ADDENDUM NUMBER: ONE (1)

DATE: May 2, 2024

PROJECT: ATHLETIC COMPLEX AT STOKES FIELD
COMMUNITY CENTER RENOVATION

DESIGNER: MONTGOMERY COUNTY ENGINEERING

**MONTGOMERY COUNTY
TENNESSEE**
ATHLETIC COMPLEX AT STOKES FIELD
ELECTRICAL - DETAILS/SCHEDULES

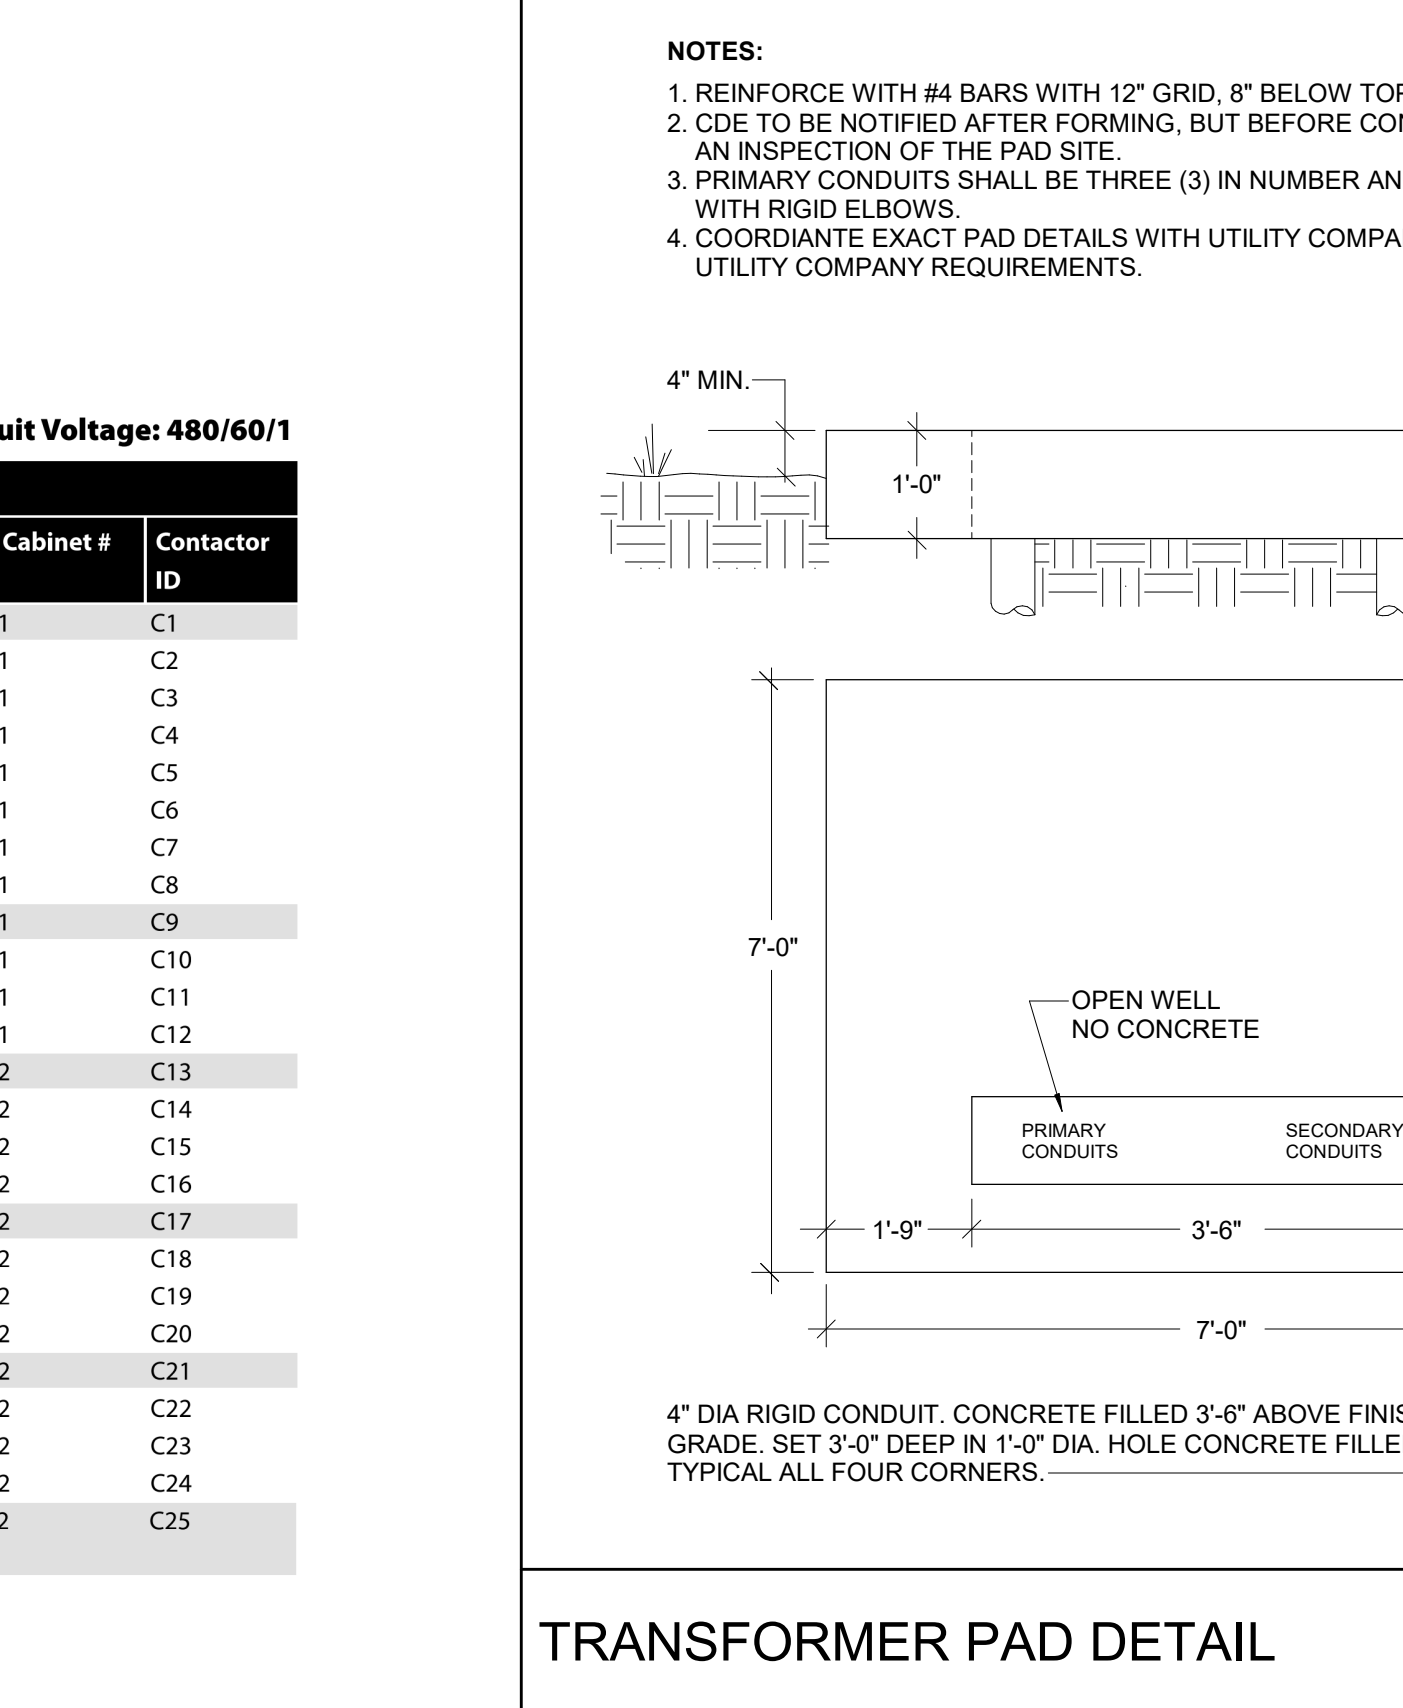
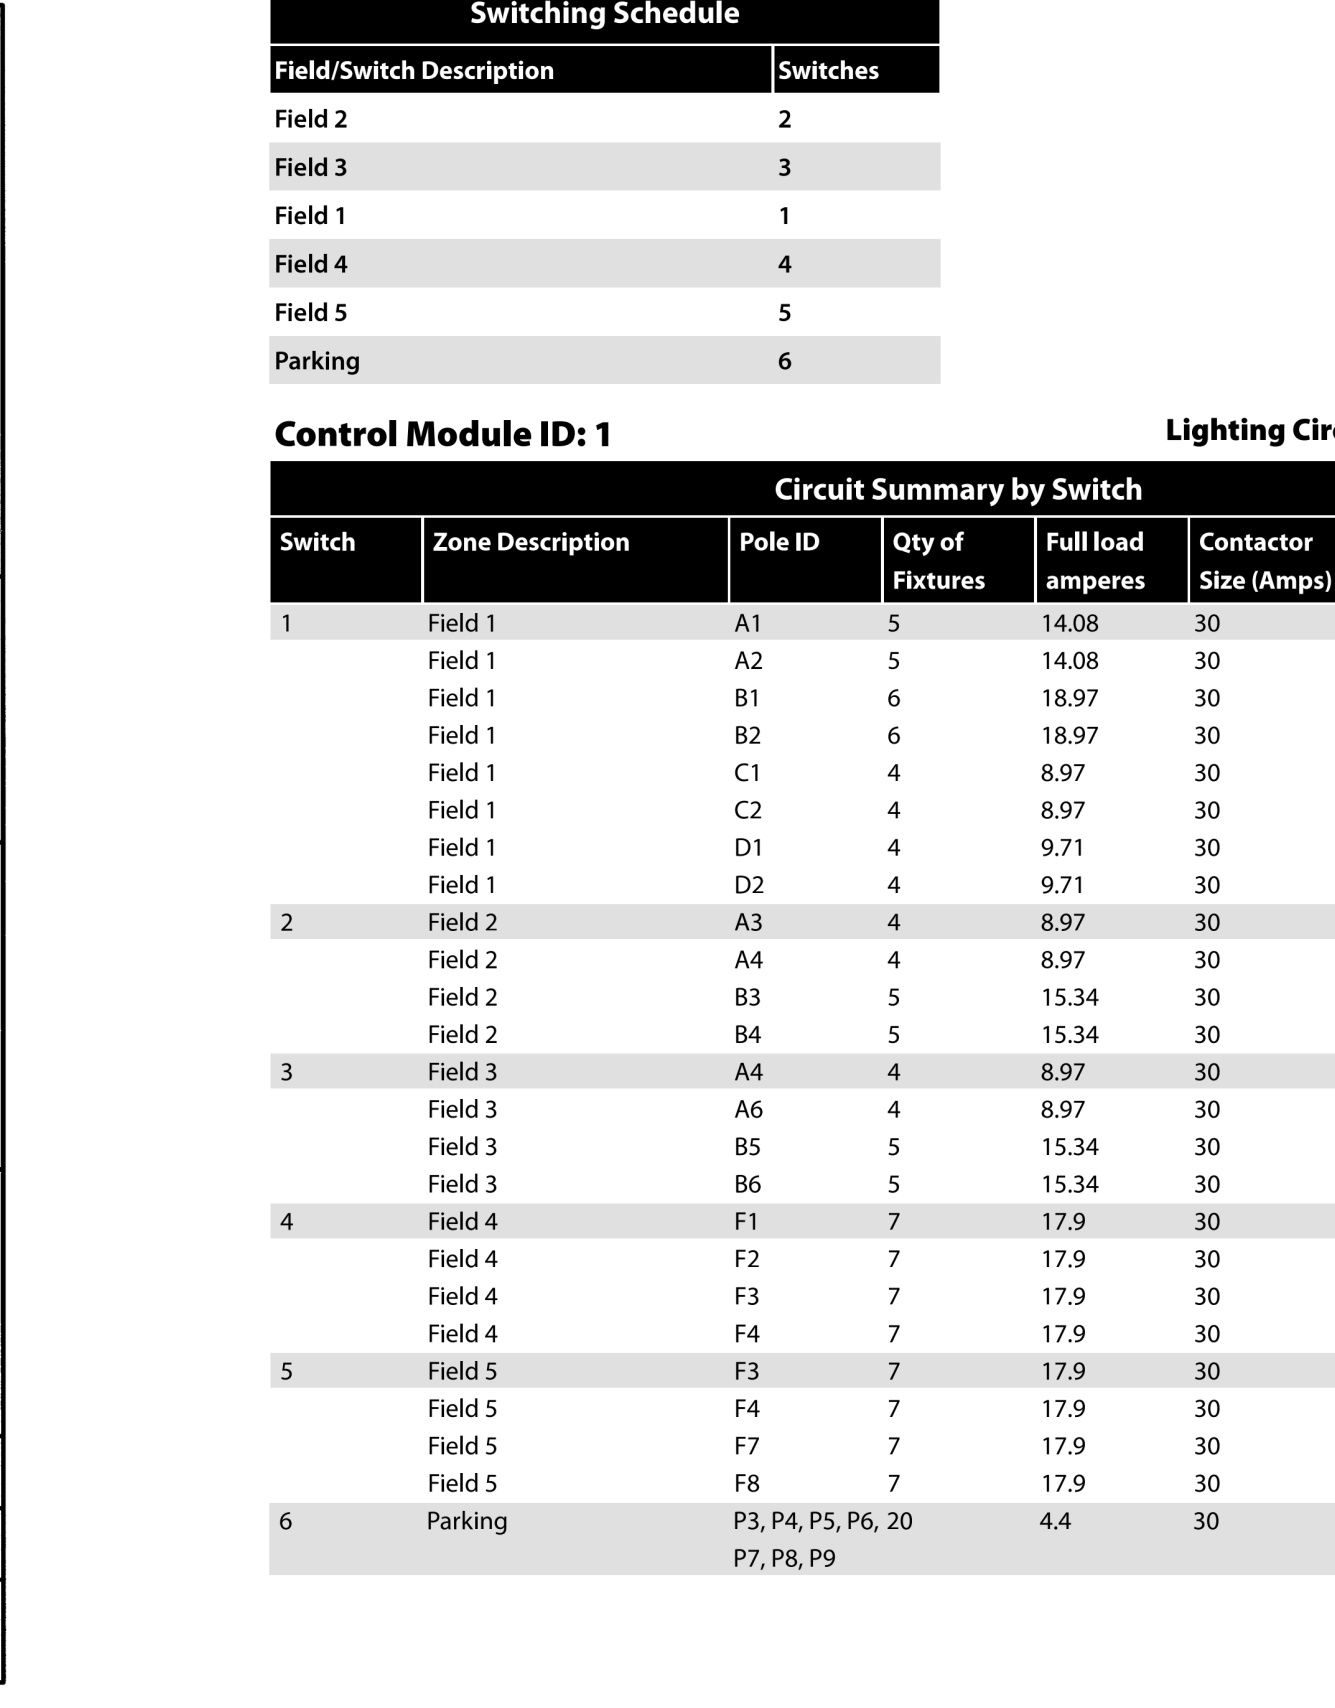
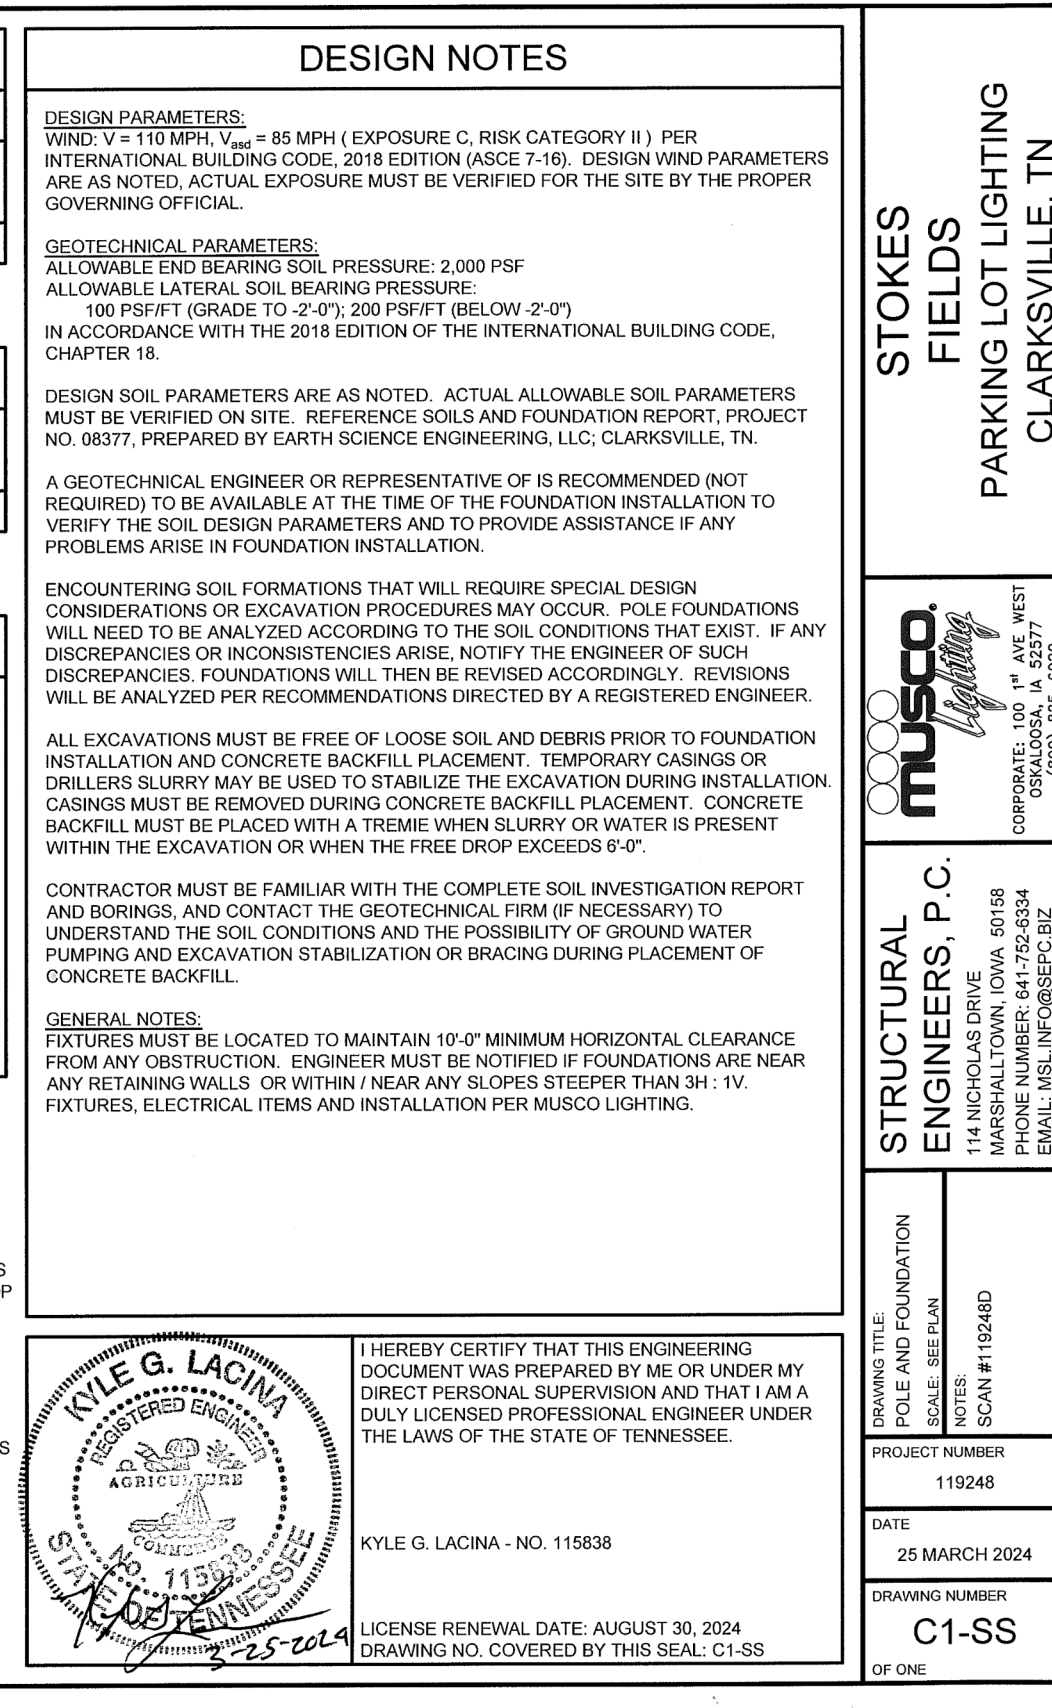
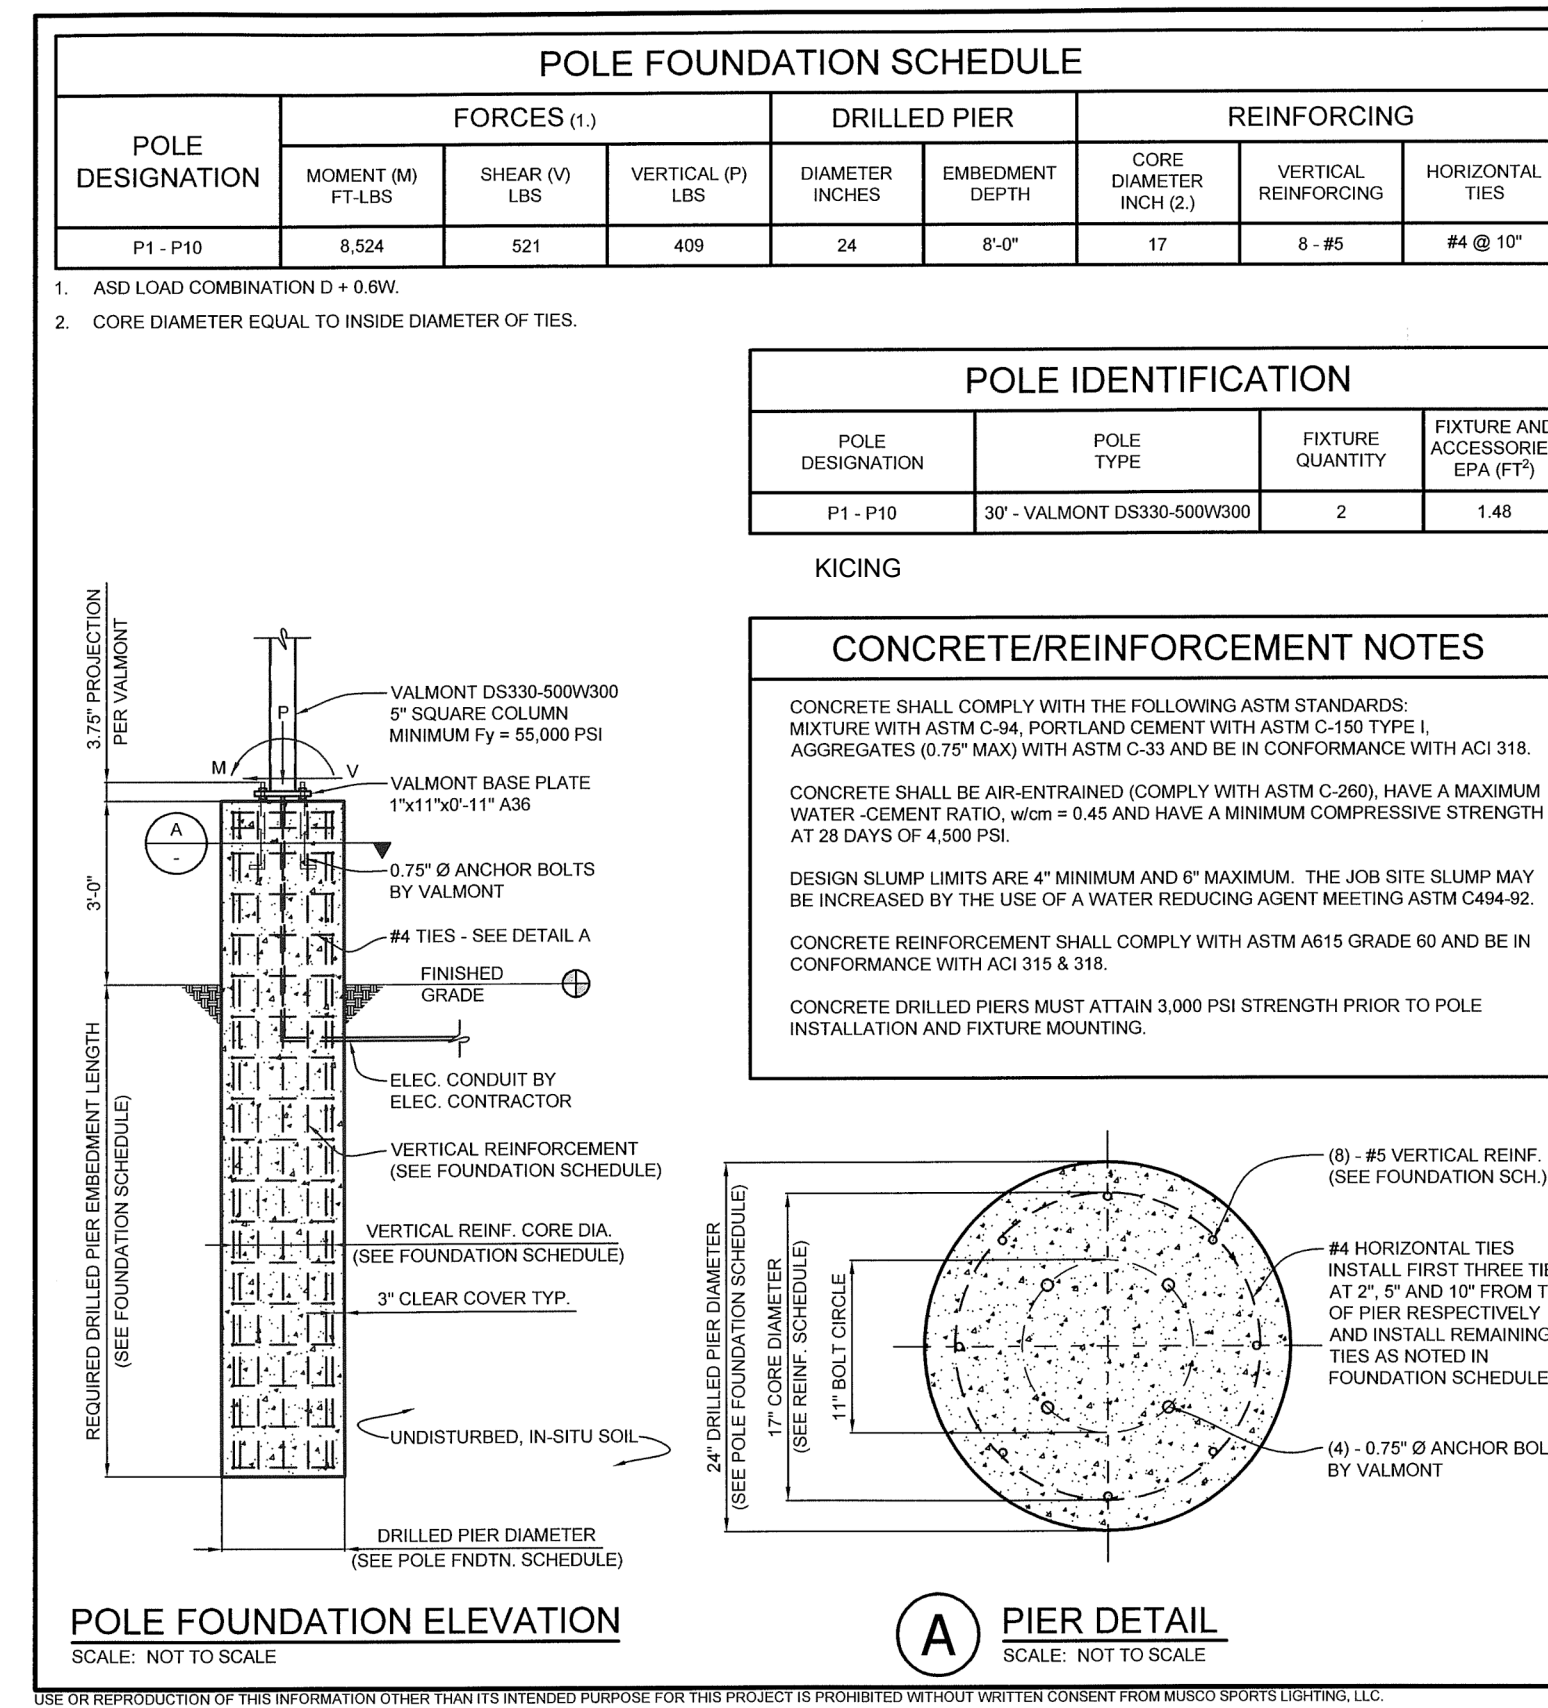
5. Drawing Sheet E5.2: Drawing E5.2 is revised and dated 4-30-24 and replaces the original E5.2. Foundation details for Field 1 poles have been added.
